Project	<b>IEEE 802.16 Broadband Wireless Access Working Group</b> < <a href="http://ieee802.org/16">http://ieee802.org/16</a> >	
Title	Corrections for downlink STC in OFDMA PHY	
Date Submitted	<b>2004-11-01</b>	
Source(s)	Yuval Lomnitz Yigal Eliaspur Intel.	<a href="mailto:Yuval.Lomnitz@intel.com">Yuval.Lomnitz@intel.com</a> <a href="mailto:Yigal.Eliaspur@intel.com">Yigal.Eliaspur@intel.com</a>
	Yigal Leiba Yossi Segal Runcom Ltd.	<a href="mailto:yigall@runcom.co.il">yigall@runcom.co.il</a> <a href="mailto:yosis@runcom.co.il">yosis@runcom.co.il</a>
Re:	IEEE P802.16REVd/D5-2004	
Abstract	Corrections and clarifications of definitions for STC in OFDMA PHY.	
Purpose	Adopt changes.	
Notice	This document has been prepared to assist IEEE 802.16. It is offered as a basis for discussion and is not binding on the contributing individual(s) or organization(s). The material in this document is subject to change in form and content after further study. The contributor(s) reserve(s) the right to add, amend or withdraw material contained herein.

# Corrections for downlink STC in OFDMA PHY

*Yuval Lomnitz, Yigal Eliaspur (Intel)  
Yigal Leiba, Yossi Segal (Runcom Ltd.)*

The following diagrams show the pilot patterns

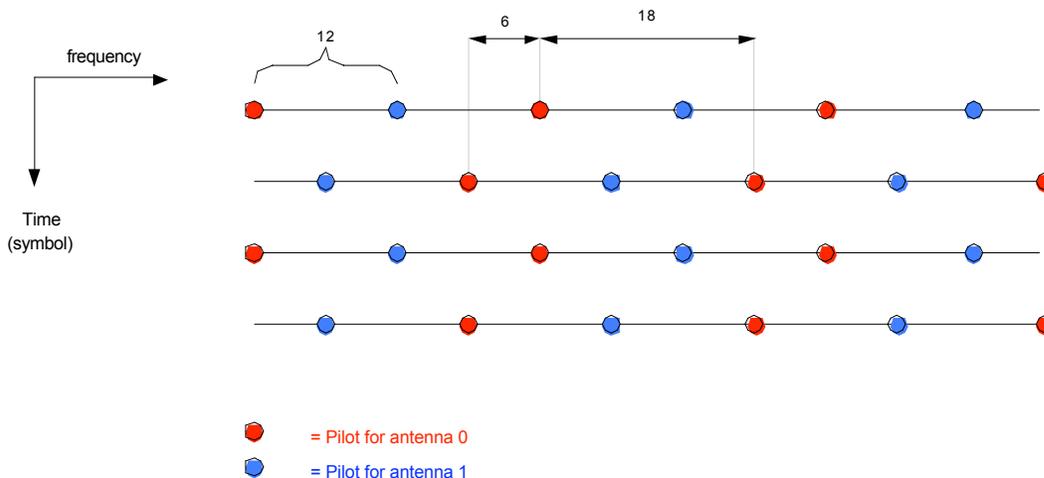
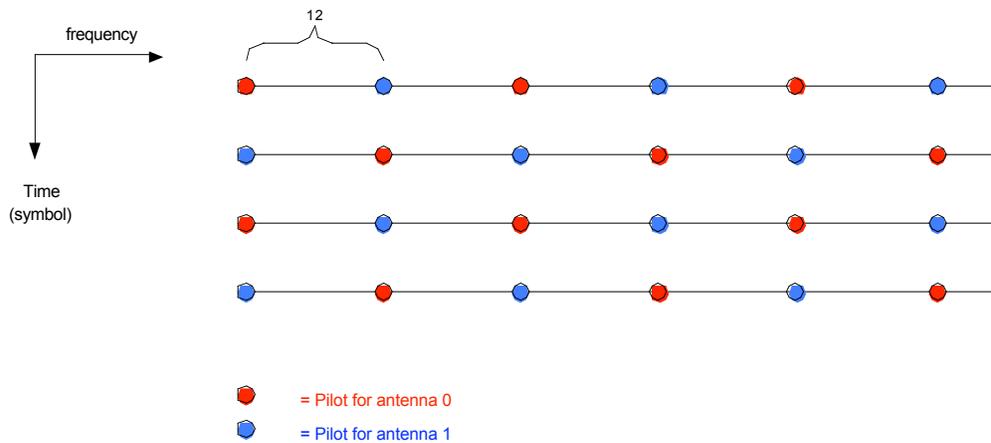
Equation (106) in section 8.4.6.1.2.2 (Symbol Structure for FUSC) defines that FUSC variable pilots are shifted by 6 in each odd symbol. However in STC they shouldn't be shifted by 6 because of the following reasons:

1. Shifting the pilots changes the location of data subcarriers, resulting in the fact that the STC doesn't operate on QAM symbols transmitted in the same frequency. This makes STC combining complex and suboptimal.
2. The operation of STC coding is defined as exchanging tones with the same index for two OFDMA symbols. The STC operation is not well defined when data tones change their locations.
3. The movement of the pilots creates an irregular pilot pattern that doesn't improve channel estimation, as depicted below. It seems that the original intention was merely to exchange pilot-sets between the antennas.

The maximum pilot spacing over 2 OFDMA symbols is 18 tones (and the minimum is 6 tones)

The pilot spacing (from one antenna) in two OFDMA symbols is 12 tones.

In FUSC all subchannels shall be used for STC transmission, the pilots within the symbols shall be divided between the antennas, antenna 0 uses VariableSet#0 and ConstantSet#0 for even symbols while antenna 1 uses VariableSet#1 and ConstantSet#1 for even symbols, antenna 0 uses VariableSet#1 and ConstantSet#0 for odd symbols while antenna 1 uses VariableSet#0 and ConstantSet#1 for odd symbols (symbol counting starts at the starting point of the relevant STC zone), defined in 8.4.6.1.2.2. **In STC transmission the variable pilots shall not be shifted according to equation (106)**. The transmission of the data shall be performed in pairs of symbols as illustrated in Figure 247.
